RESPONSES TO PUBLIC COMMENTS

INITIAL STUDY/MITIGATED NEGATIVE DECLARATION

VILLA SERENA SPECIFIC PLAN

CITY OF UPLAND

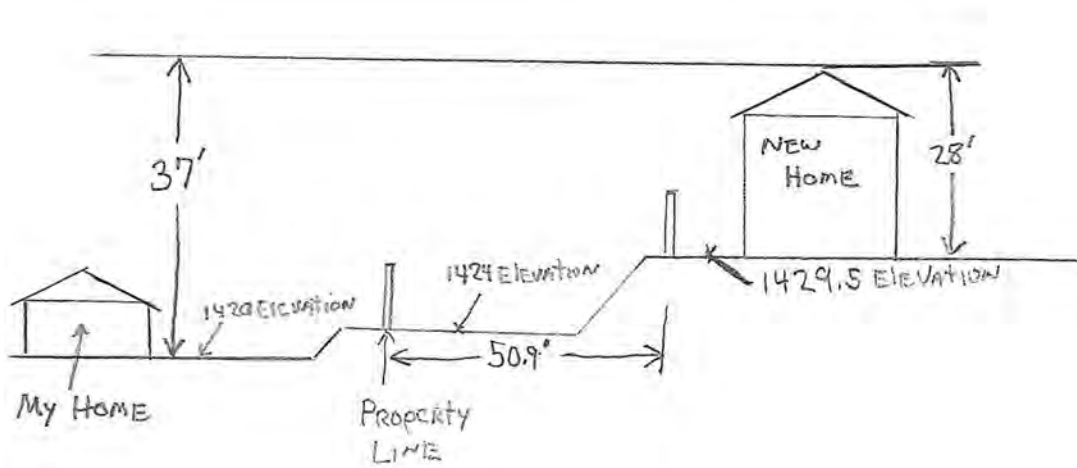
In summation, with the one plus year of construction noise, dust and traffic, the loss of our mountain views and the tremendous increase of street traffic on 15th Street after the project is completed, and with other concerns my hope is that the Planning Commission will not recommend the Project for approval as presented but refer it back to Frontier Communities to address the concerns of existing Upland residents.

C-6

Response to Comment C-6: The IS/MND analysis is based on evidence included in project-specific technical studies. Where potential environmental impacts resulting from the construction and operation of the project have been identified, appropriate mitigation measures and standard conditions have been included in the IS/MND to reduce impacts to a less than significant level. The commenter's "hope" regarding future Planning Commission action is noted and will be fully considered prior to and during any public hearing on the project.
